**COMMENTS RECEIVED
ON
DRAFT EIR**

RE: Comments - Draft EIR 546 - Proposed Amendment - Phase 2 Access Plan.

SUBJECT: RESPONSE TO DRAFT ENVIRONMENTAL IMPACT REPORT NO. 546.

Re: DRAFT EIR #546
JOHN WAYNE AIRPORT PHASE 2 ACCESS PLAN

Figure 1
JOHN WAYNE AIRPORT
Orange County, California
1991 CNEL CONTOURS

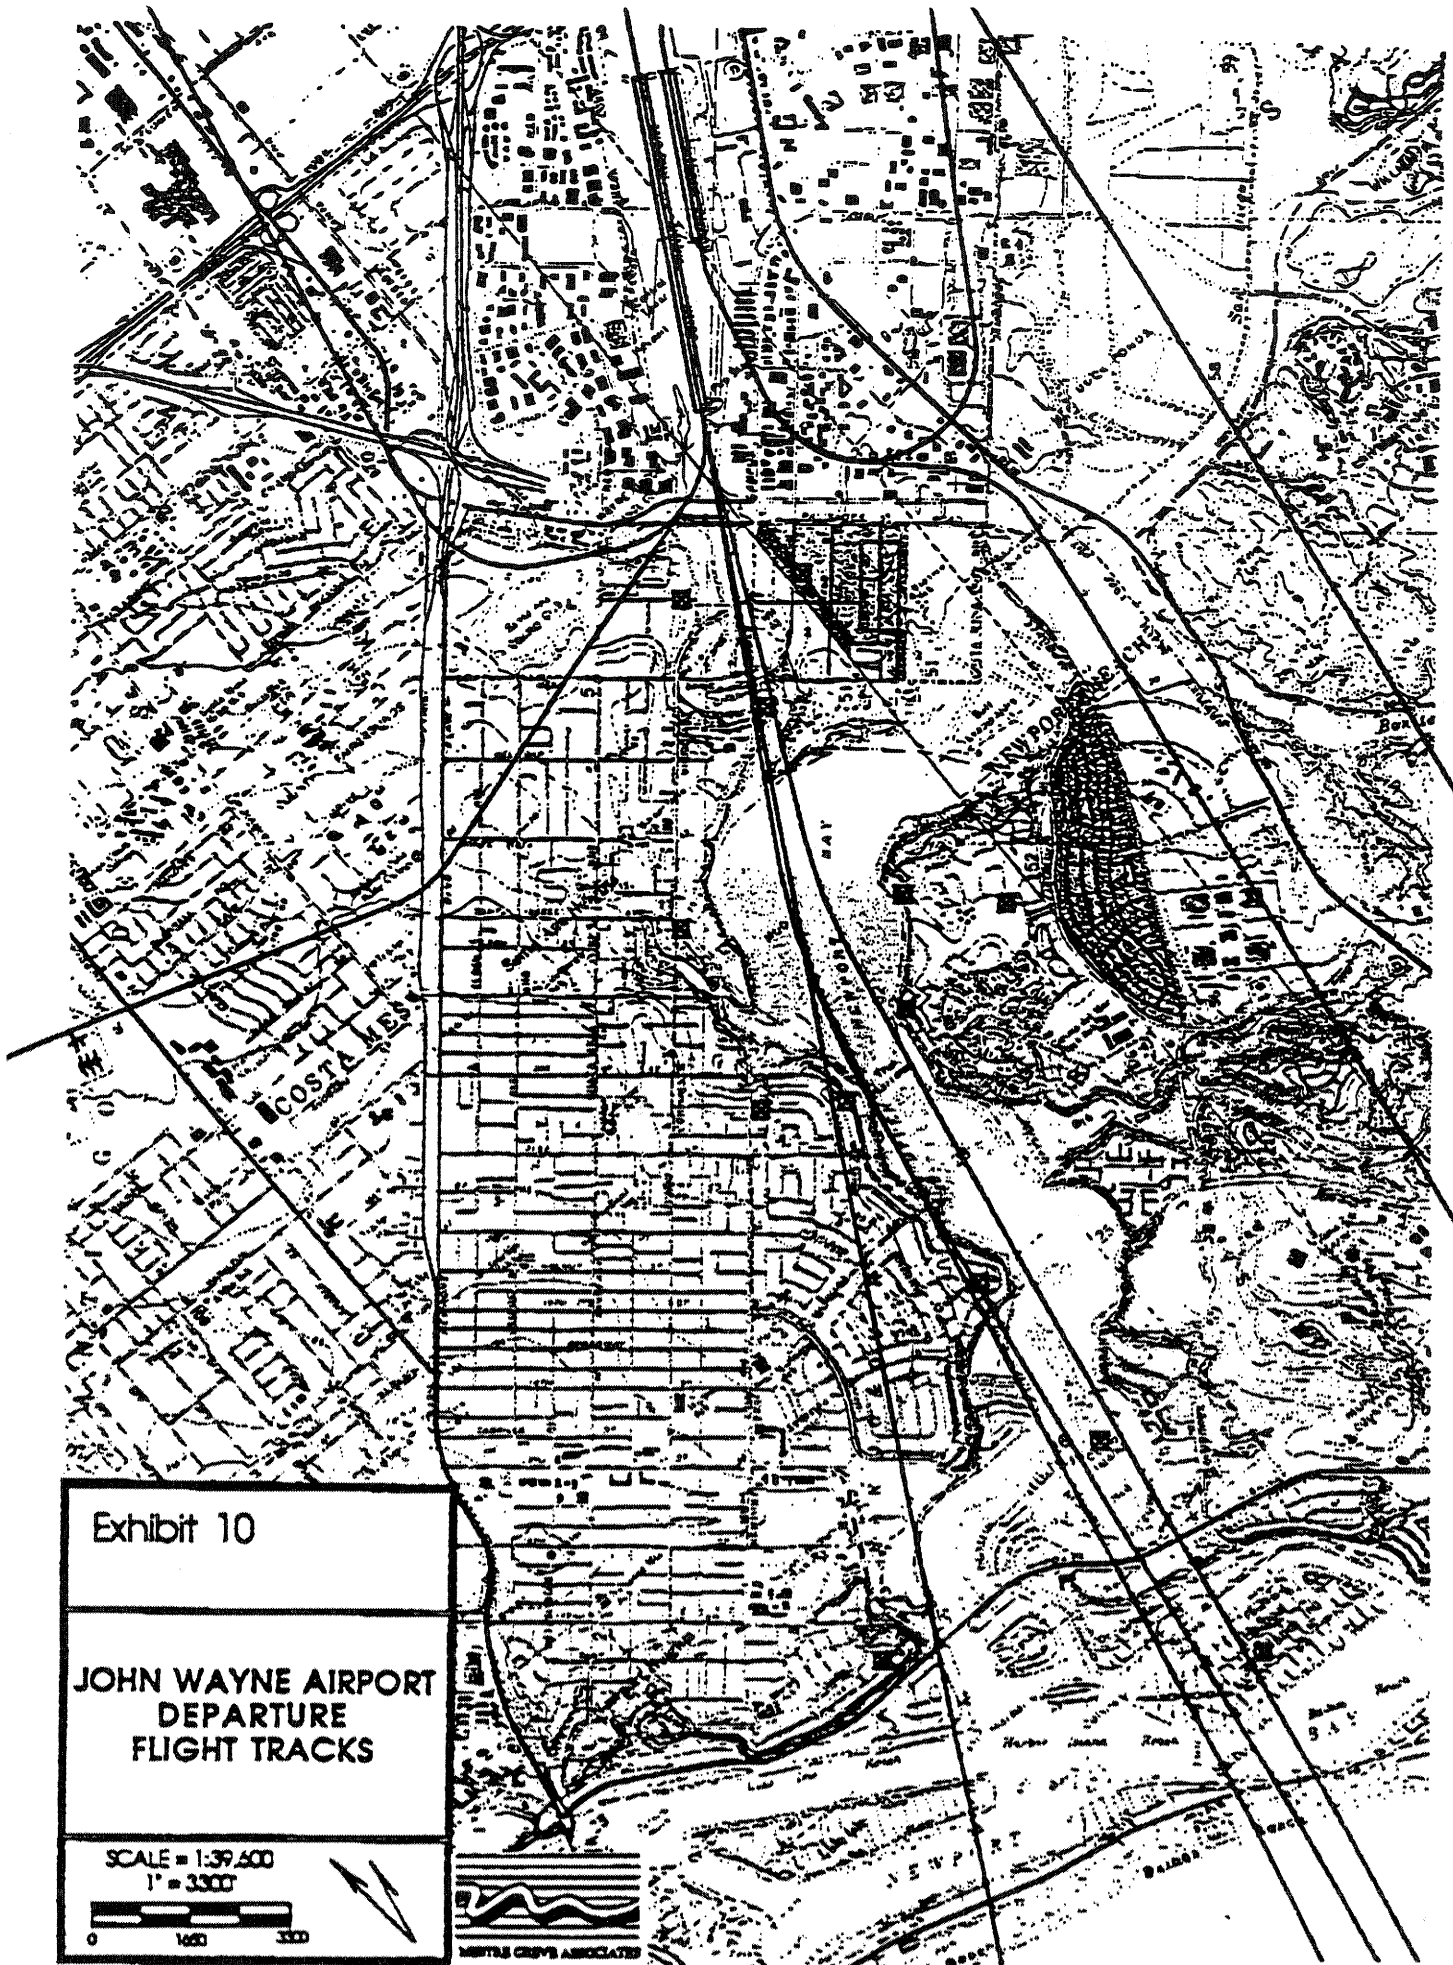
The precision of the Exhibit 12 65 dB CNEL noise contour location is dependent upon the field noise measurement accuracy and the computer model matching of the noise level data. While general aviation aircraft do turn both left and right from the SID (as described in the Response No. 25 above), and some of these operations may fly over the Riverside Drive Kennel Owners Group area, the impact of these operations have been entirely accounted for by the noise level data collection. Further, since the air carrier operations tend to dominate the CNEL values in this area, the general aviation operations which do occur result in only a small contribution to the overall CNEL, and have, at best, a minor impact on the location of the 65 dB CNEL contour.

Exhibit 15a

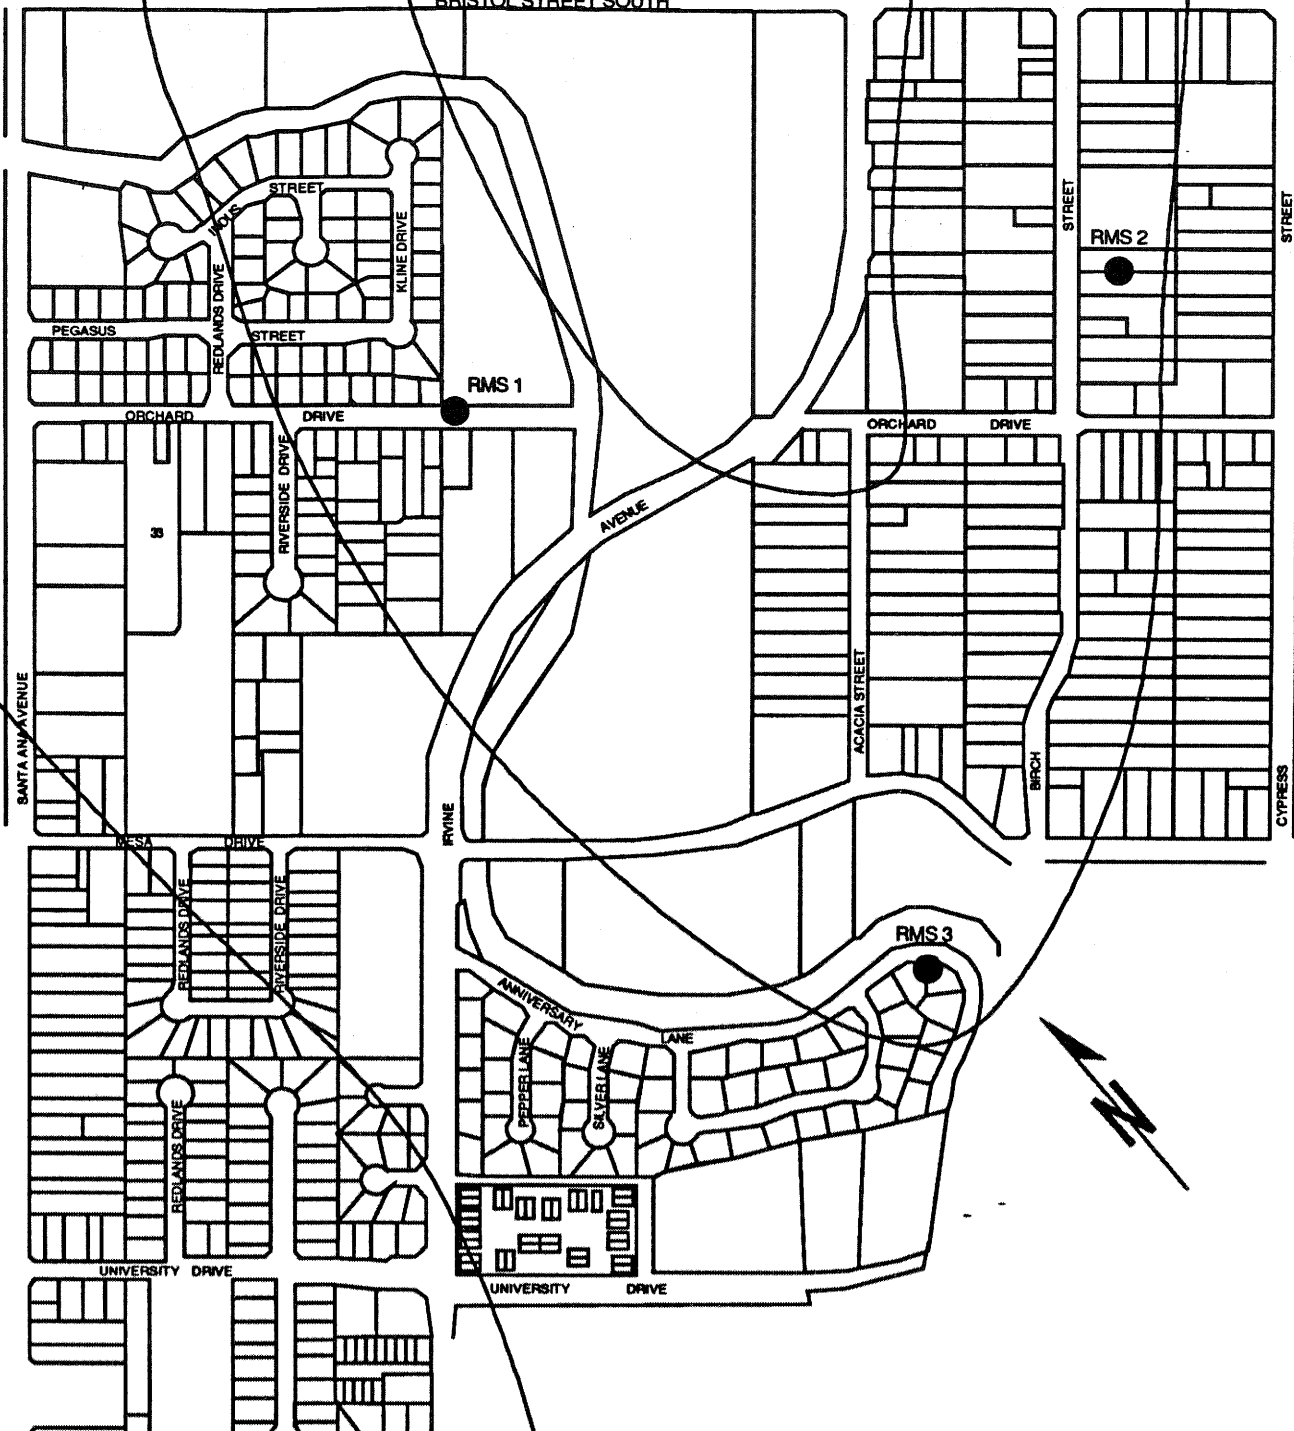
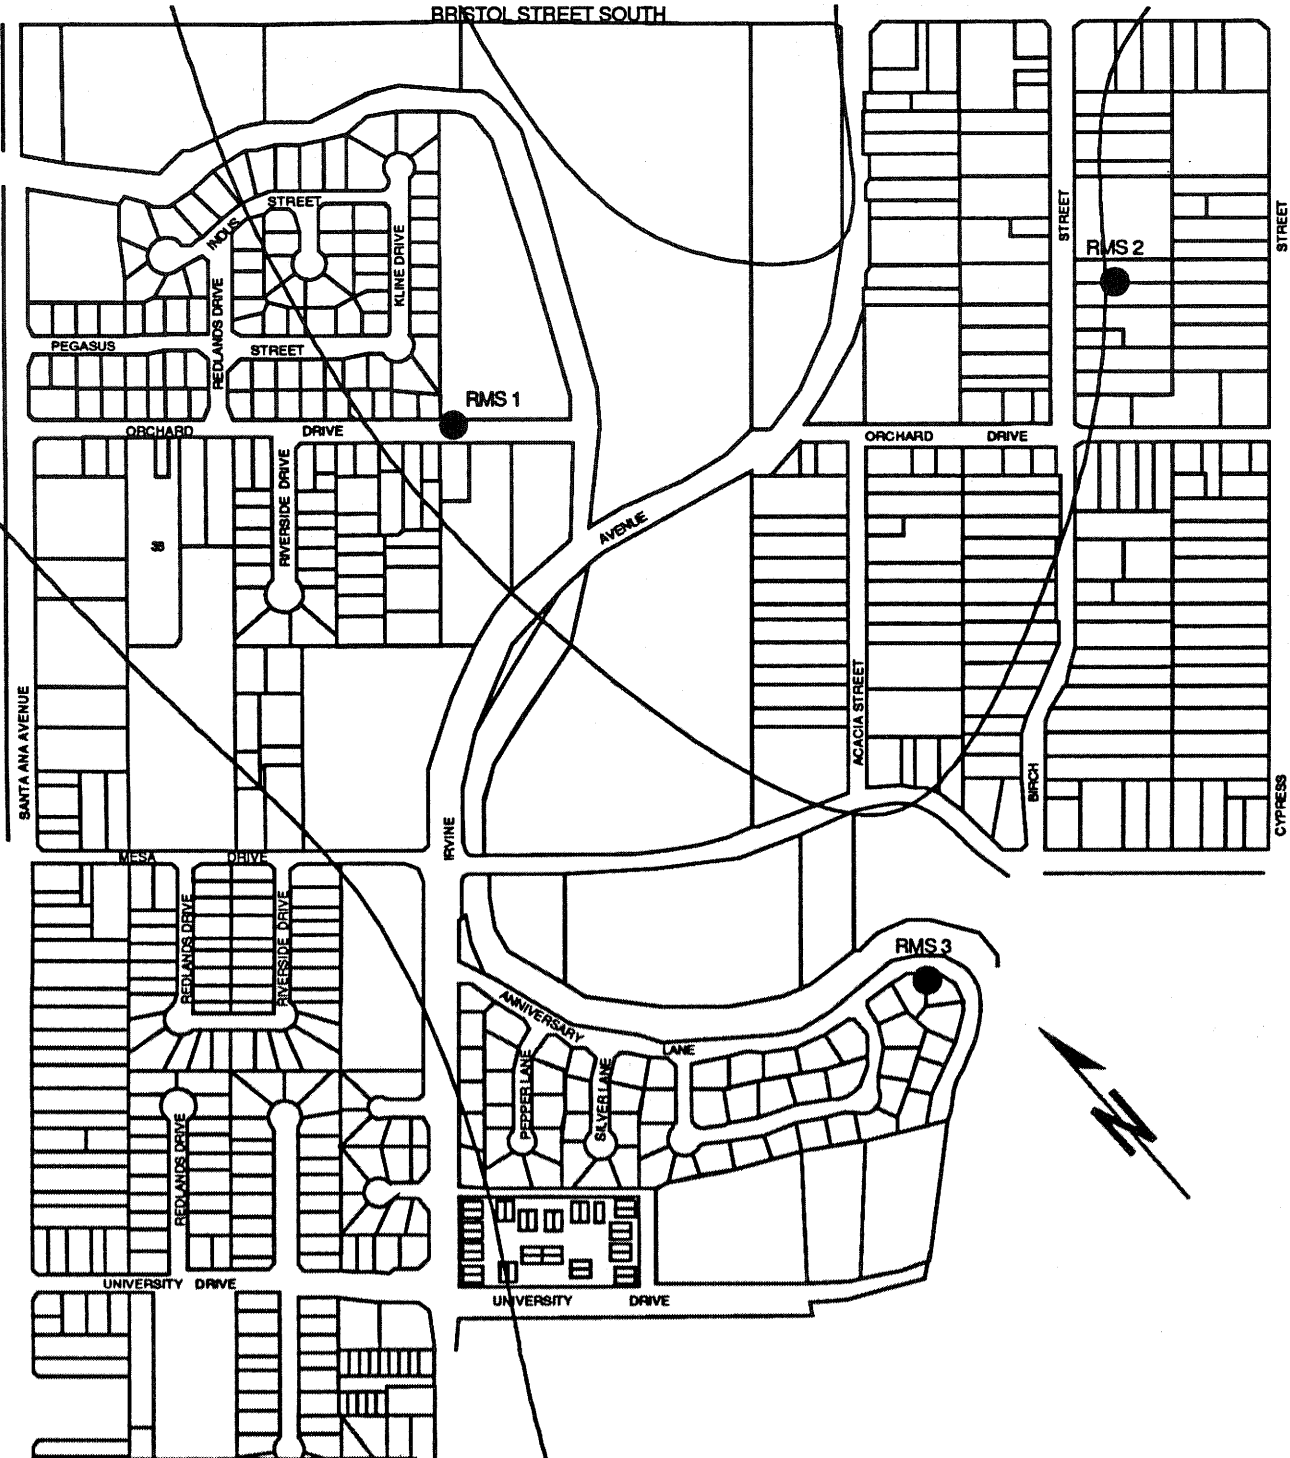
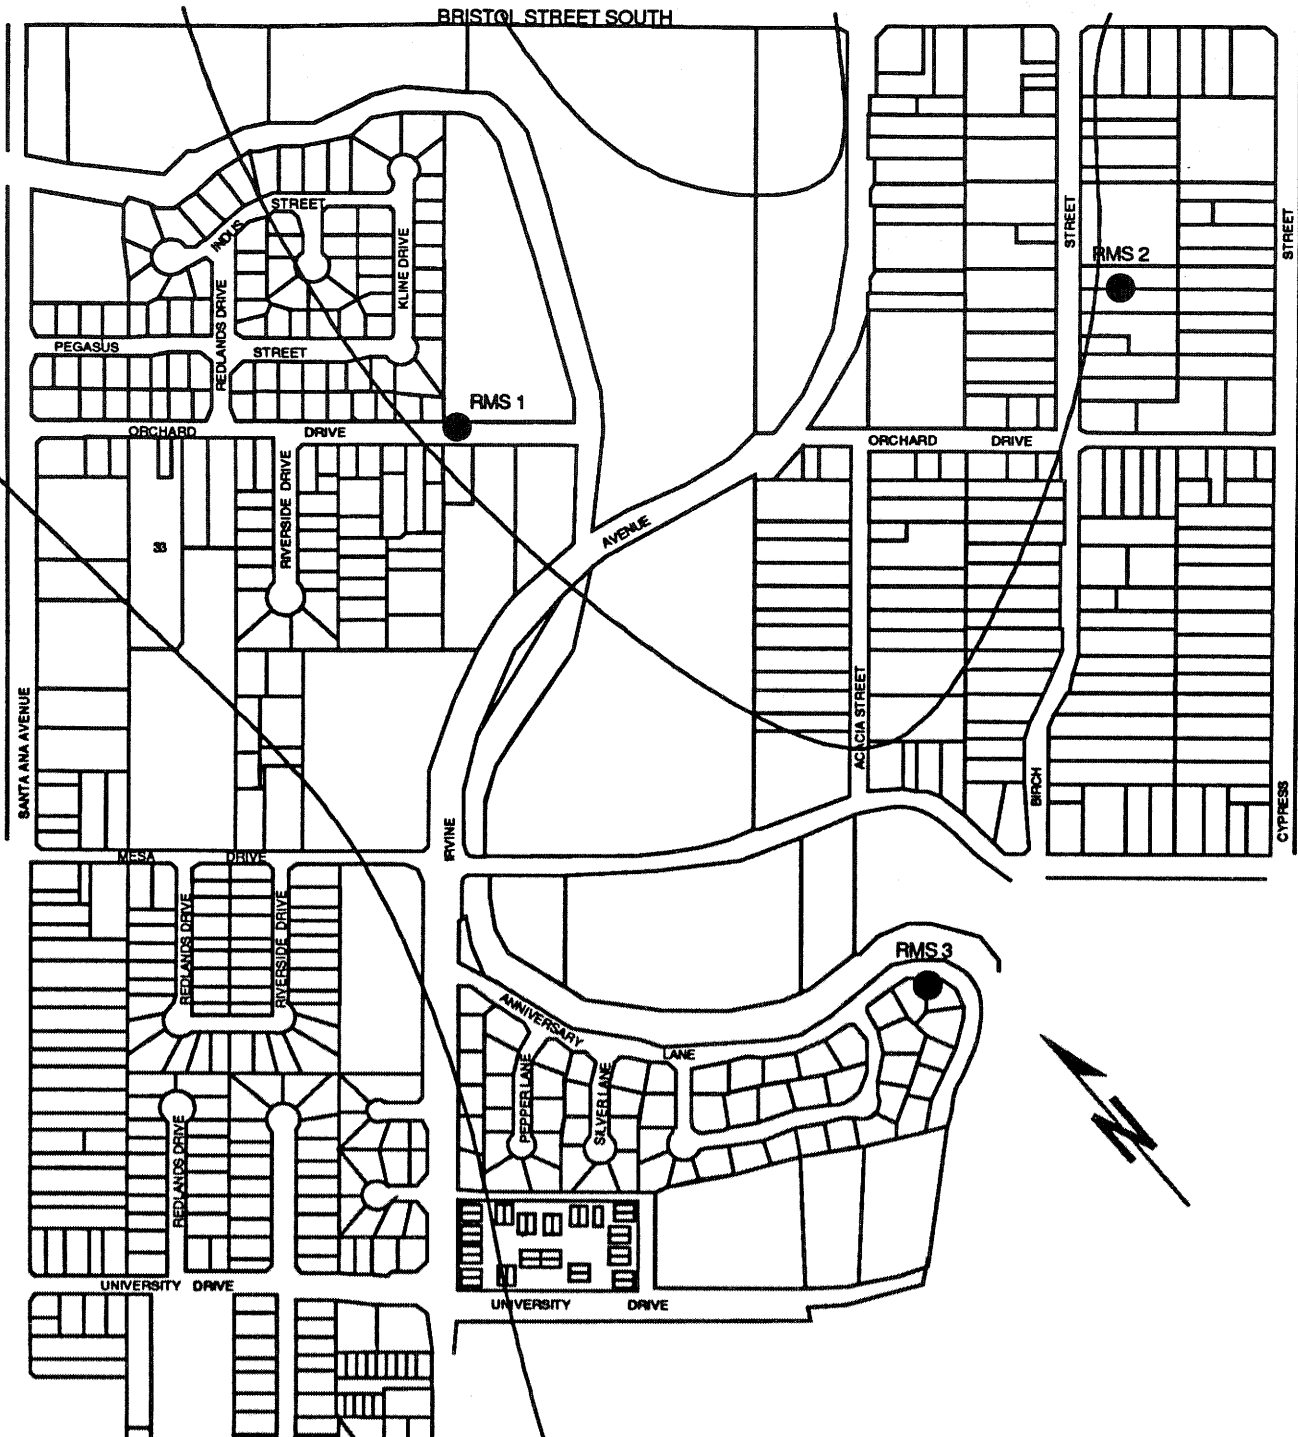
Last, we are having a hard time accepting the Appendix D, Noise Technical Appendix, as presented in the EIR #546 by Mestre Greve Associates. In the SENEL Contours, the RMS are set to monitor all commercial departures, but few of the general aviation departures. I do not believe the CNEL averages are accurate because of this. I have personally monitored private aircraft over my home that are will above 85dB. I was shocked at several twin engined departures that I call "Sky Kings" (maybe that radio show was before your time) that went over 92 dB on my meter. The all time noise maker is a twin-boomed thing with a puller engine in front and a pusher engine in the rear of the central fuselage. That thing hit 109 dB on six touch and go's. I finally called Noise Abatement and complained. Noise Abatement returned my call and stated that a student pilot had the manifold pressure set at 135 pounds and corrected the problem. I have enclosed Exhibit 12 with General Aviation departures marked as we see them day in and day out. It would seem reasonable to me that the 65 CNEL impact area should be extended to the south/west to include the greater portion of the Lang Drive Project. Even though Exhibit 12 says April 1991-March 1992, I believe it should depict Exhibit 15a, with the exception that the 60dB contour line would be in fact the 65 or 70 dB CNEL contour line. In any case I just can not buy the Mestre Greve projected data of Exhibits 15a, 15b and 15c.

Question: Why did the 750 foot and 1,000 foot runway extension theory receive so much unwarranted discussion in the Project, when the improbability was so obvious?
